**Replat—Alpine Village South Addition Replat 1—
CLR Development, LLC**

RECOMMENDATION REPORT

CASE NUMBERS: PRP20-0001;

RE: Administrative Plat Application – Initial Review
Alpine Village South Addition Replat 1

FINAL PLAT

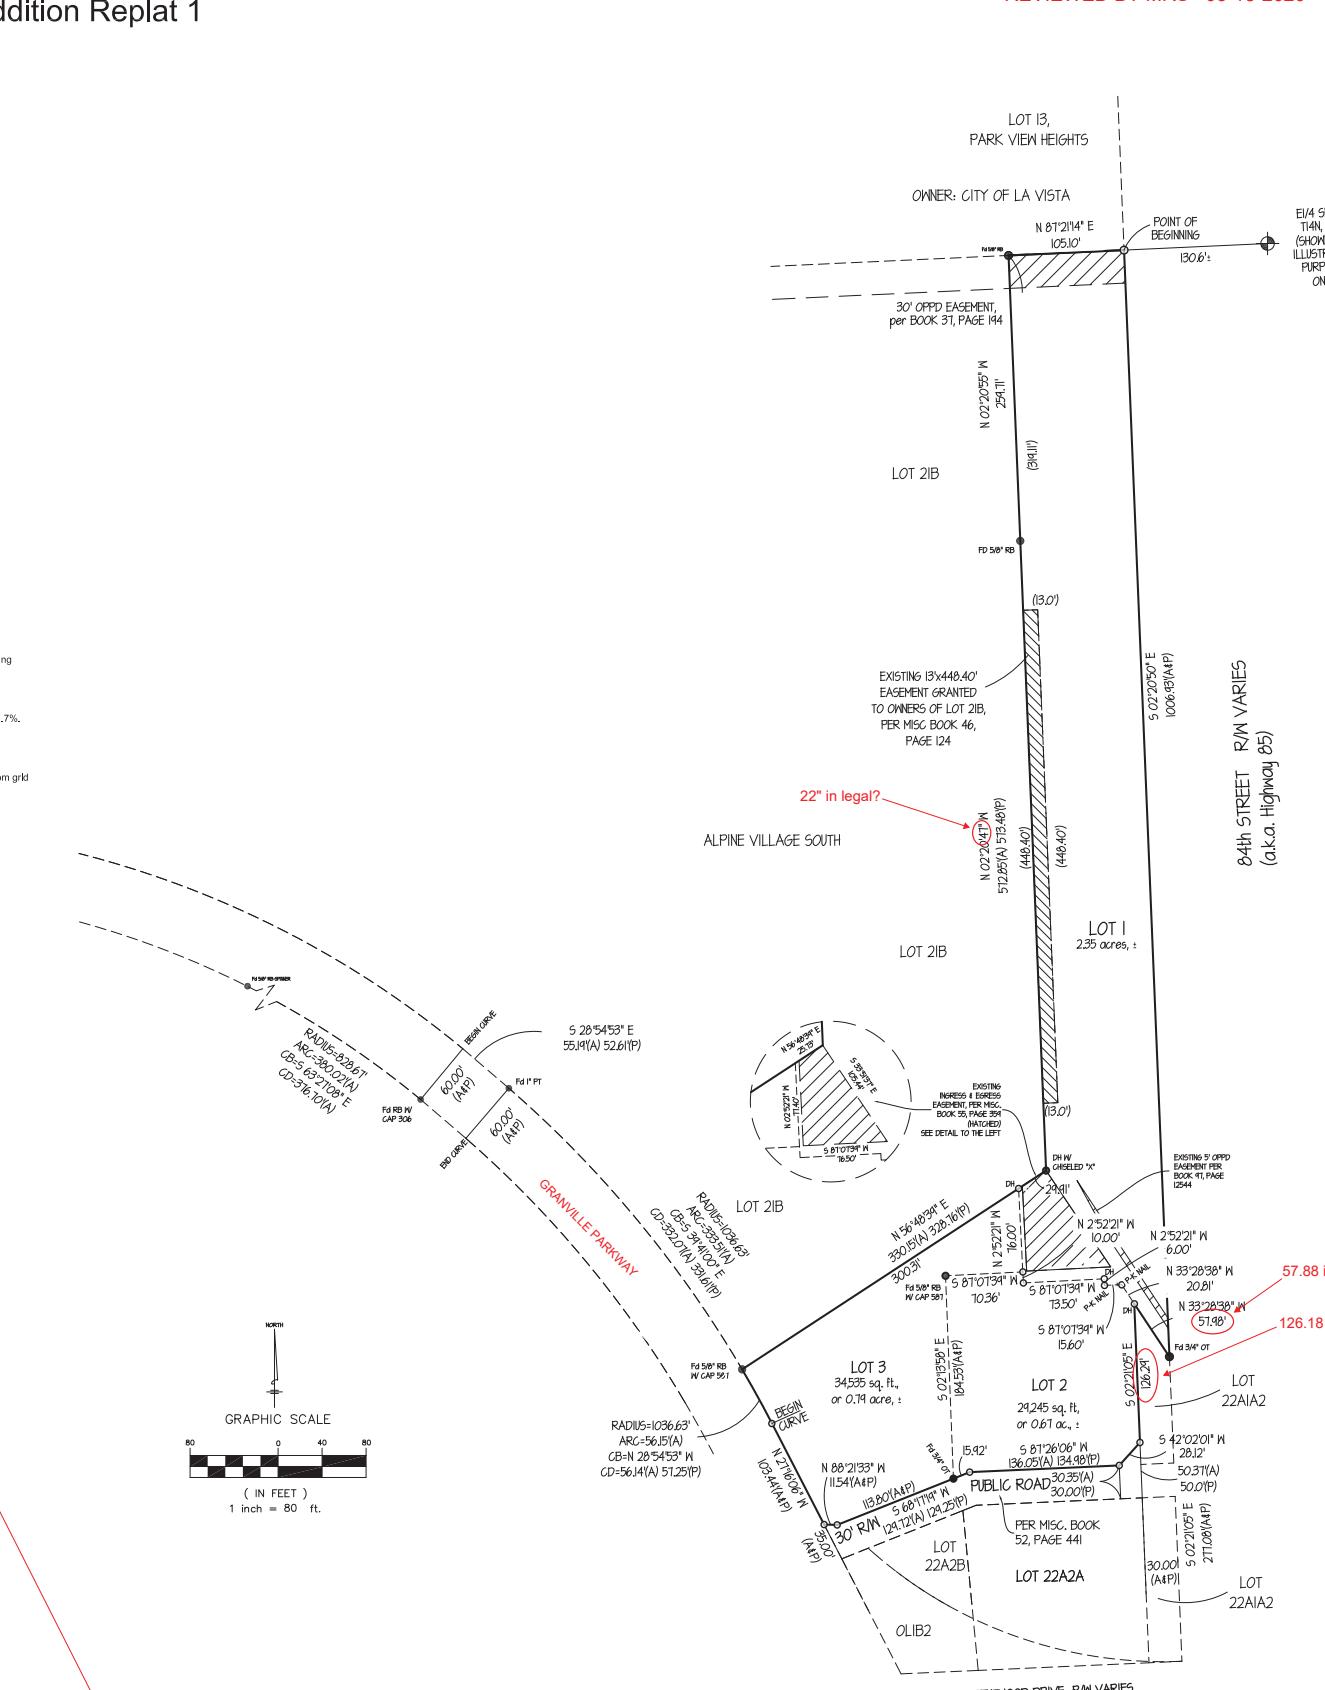
1. Please address the redlines submitted by Sarpy County Public Works that were sent to you on or about March 18, 2020. (see attached)
2. Section 3.05.09 – Lot areas should be measured in square feet.

Add what's in parenthesis

Add Final plat somewhere in title block

Preliminary Plat
for major subdivision

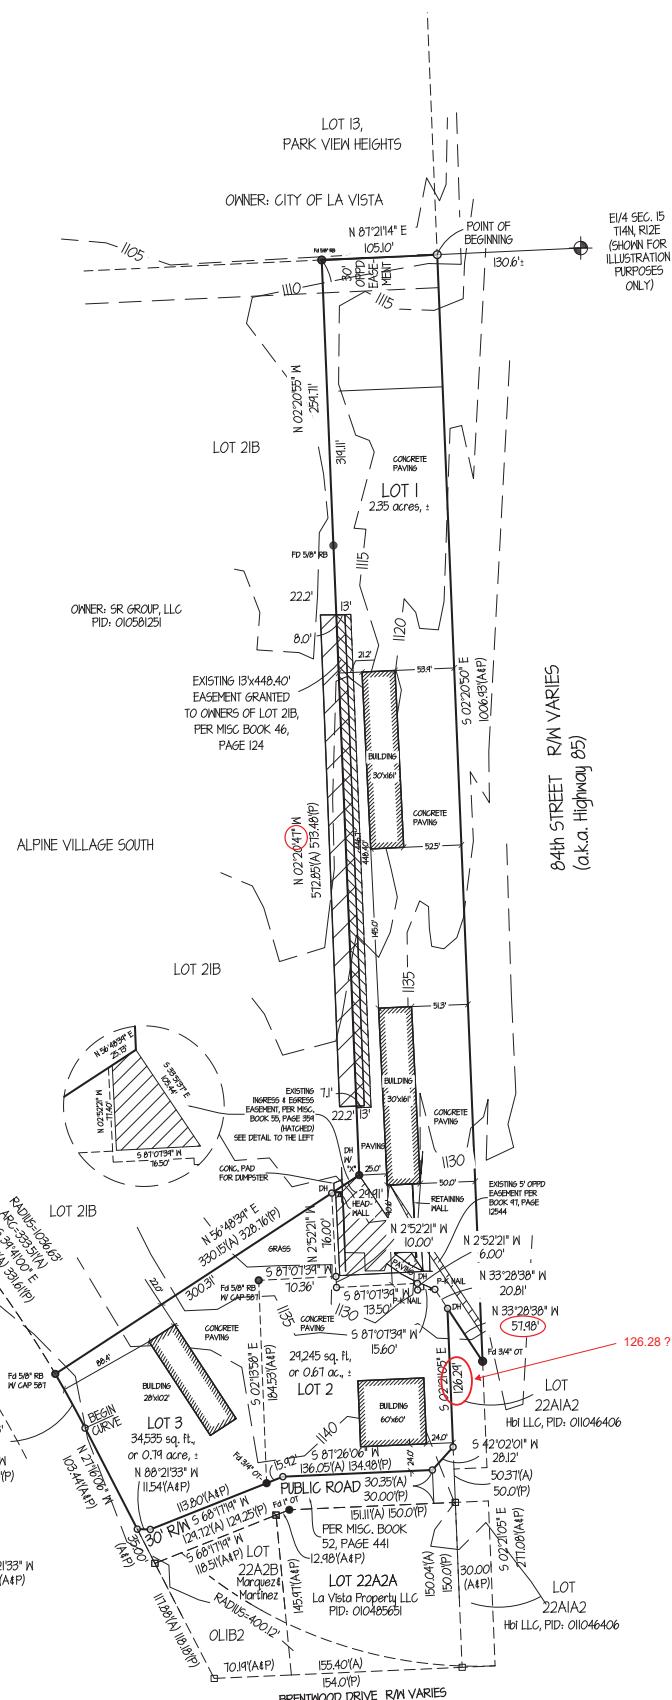
1. Please address the redlines submitted by Sarpy County Public Works that were sent to you on or about March 18, 2020. (see attached)
2. Section 3.03.07 – Plat indicates existing buildings are single story, but the buildings appear to be multi-story.
3. Section 3.03.09 – Lot areas should be measured in square feet.

Put in title block.

1 DISTANCE DIFFERENCE
FROM THE LEGAL
3-18-2020
TT

FINAL PLAT

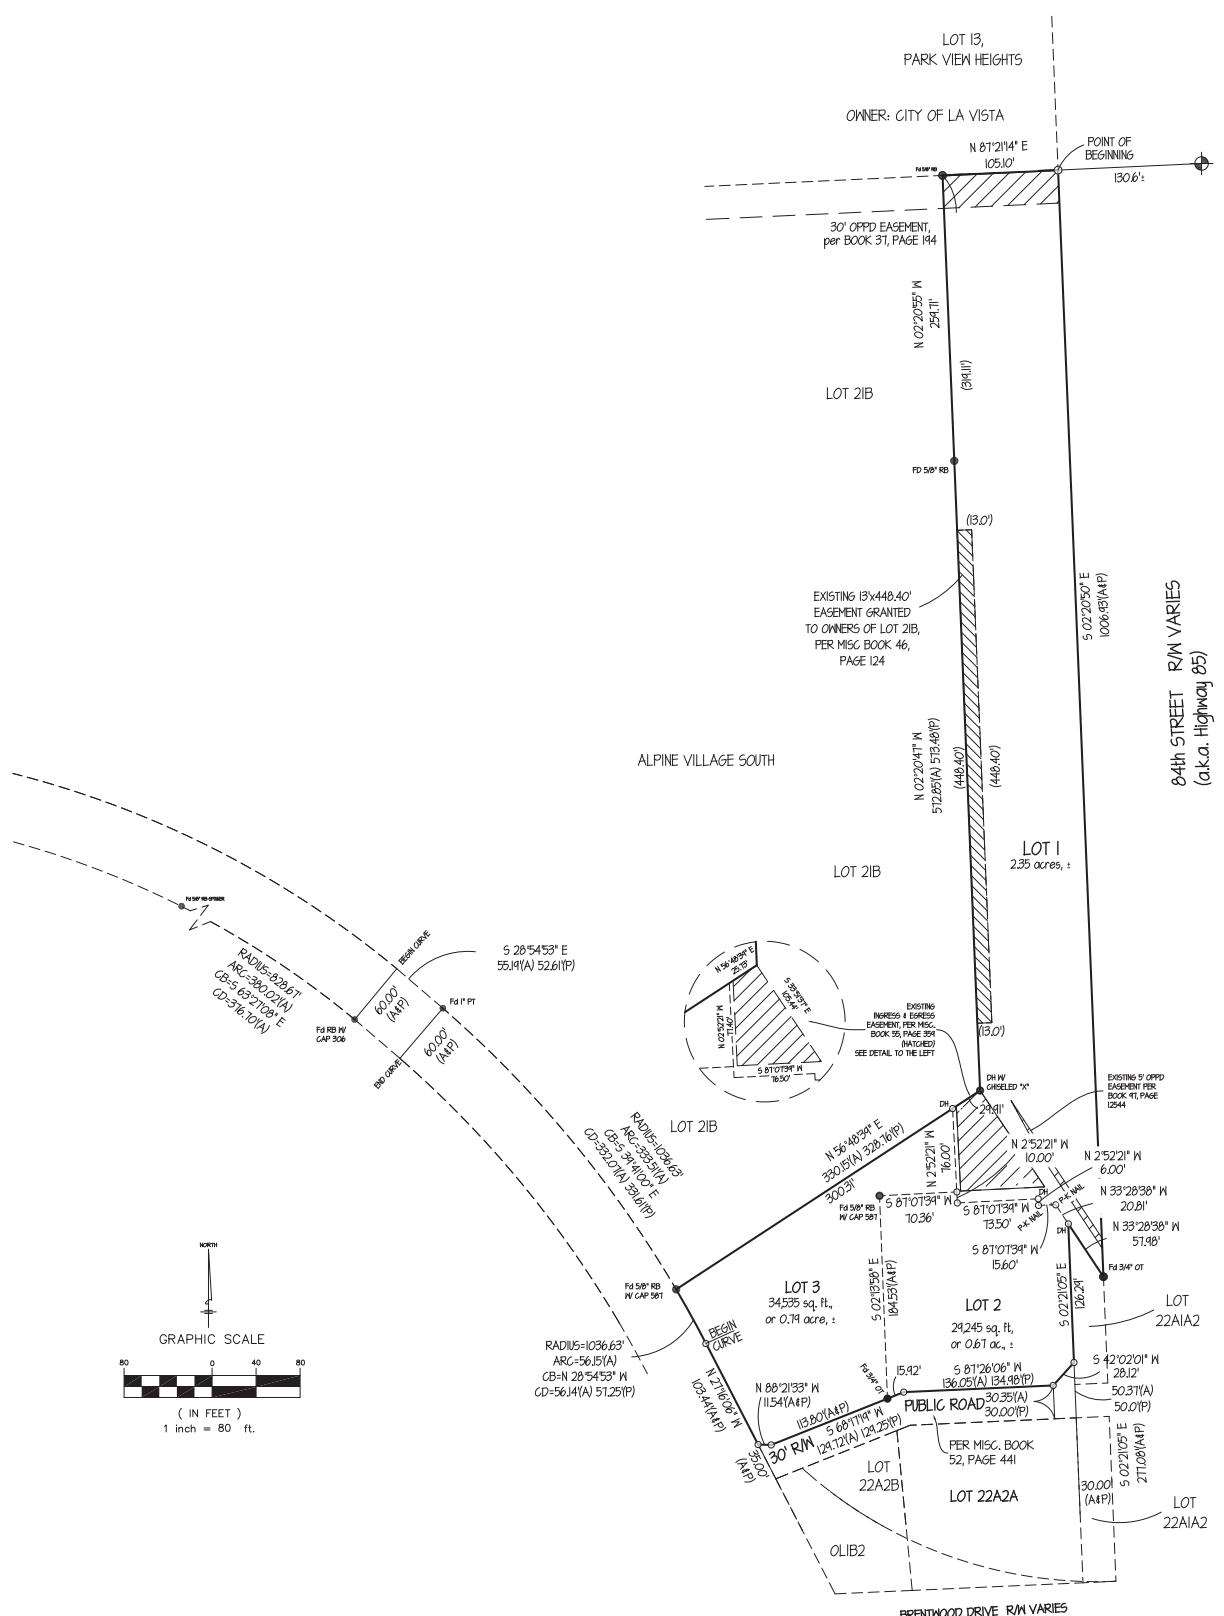
1. If you are having issues with legibility, you may rotate north to the left which will give more space for a larger scale/larger drawing.
2. The signature line for the Sarpy County review block is missing in the bottom left corner.
